Change No. 11

License No. DPR-28

Docket No. 50-271

Your letter dated September 25, 1973, proposed changes to the Technical Specifications of Facility License No. DPR-28 for the Vermont Yankee Nuclear Power Station that would reduce the maximum average planar heat generation rate for those fuel assemblies with deviant fuel enrichments to achieve conformance with the ECCS Interim Acceptance Criteria. The proposed change would provide an additional graph to Figure 3.5.1 of the Technical Specifications for the Vermont Yankee plant for those fuel assemblies containing deviant fuel enrichments.

MAXIMUM AVERAGE PLANAR LHGR (kW/ft²)FIGURE 3.5.1A MAXIMUM ALLOWABLE PLANAR LHGR

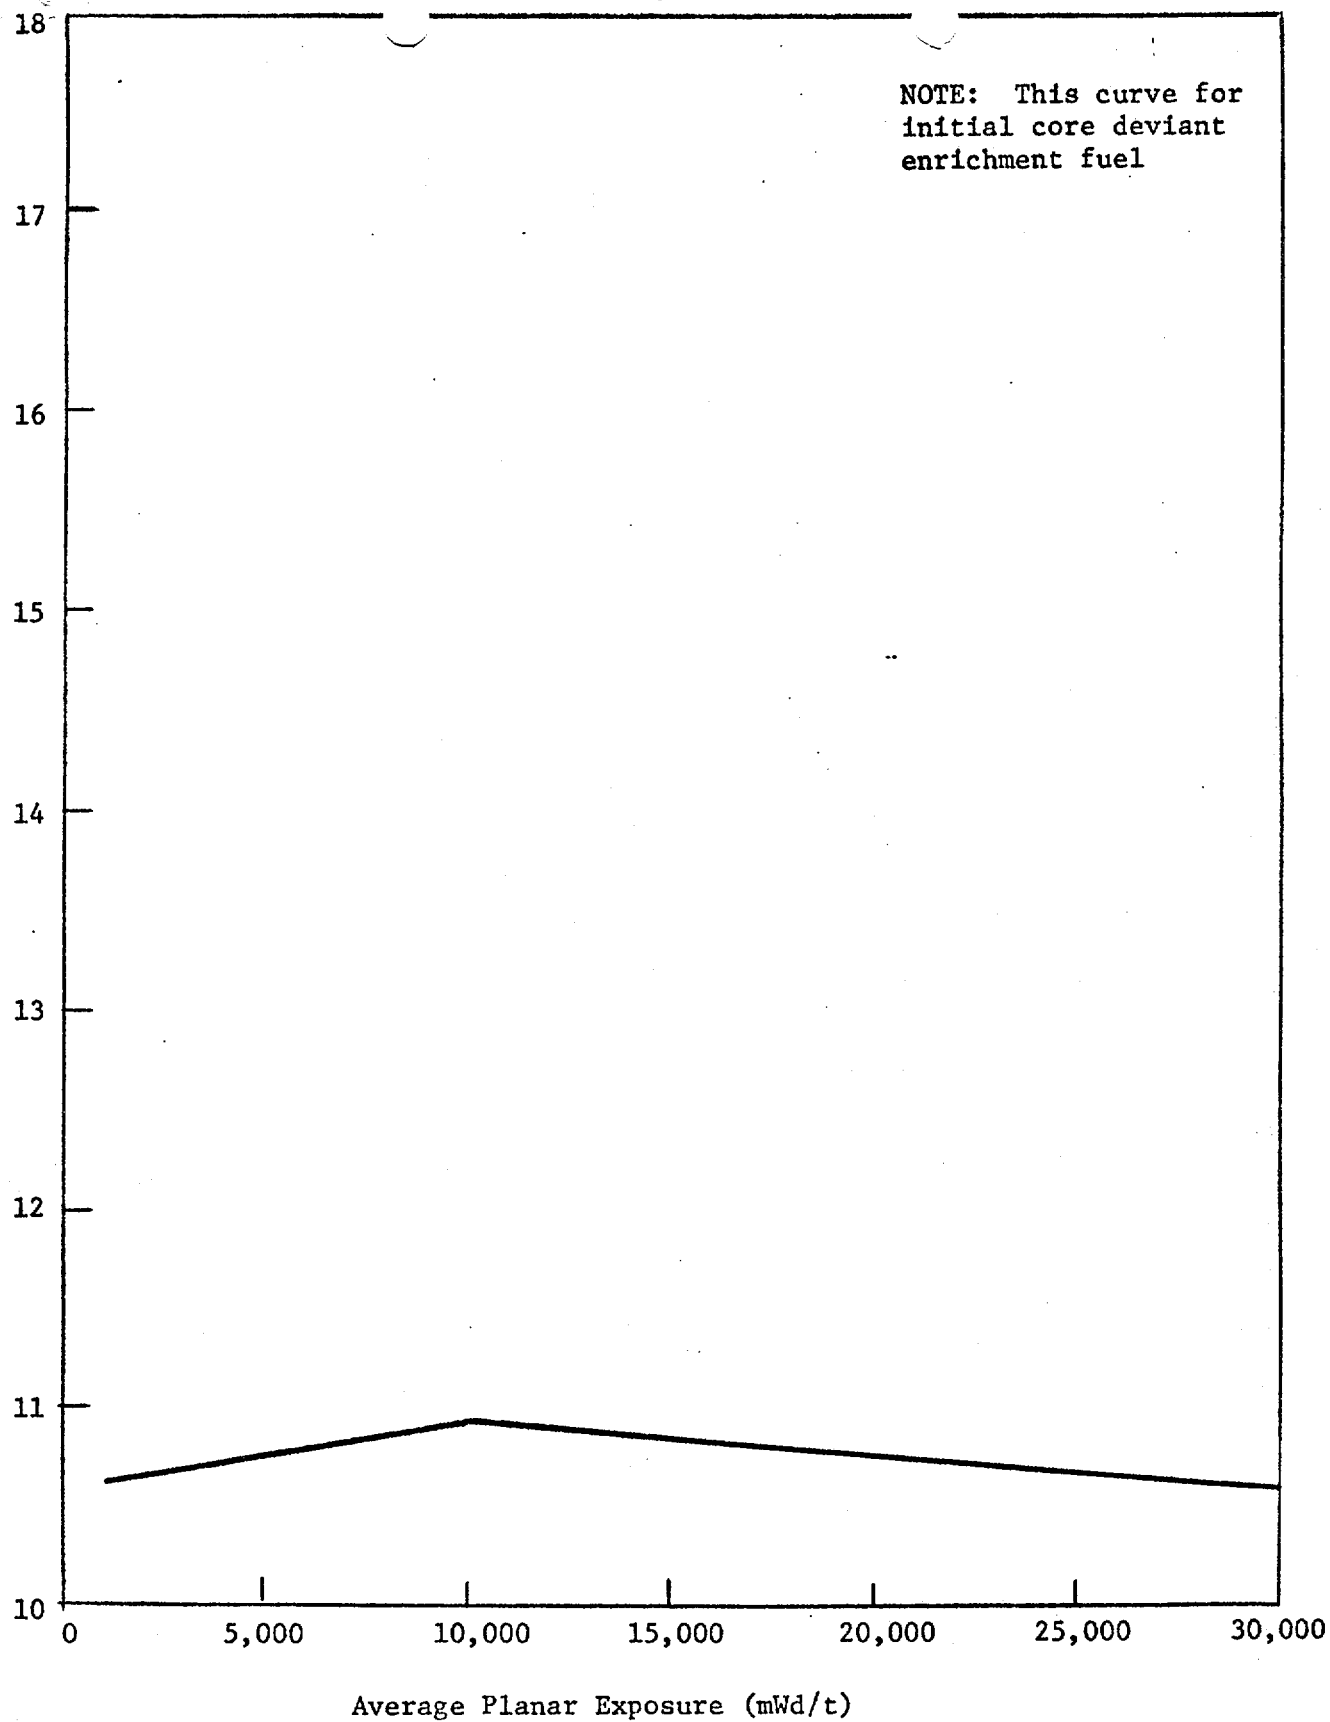
Accordingly, pursuant to Section 50.59 of 10 CFR Part 50, the Technical Specifications appended to Facility License No. DPR-28 are hereby changed by adding the enclosed Figure 3.5.1A.
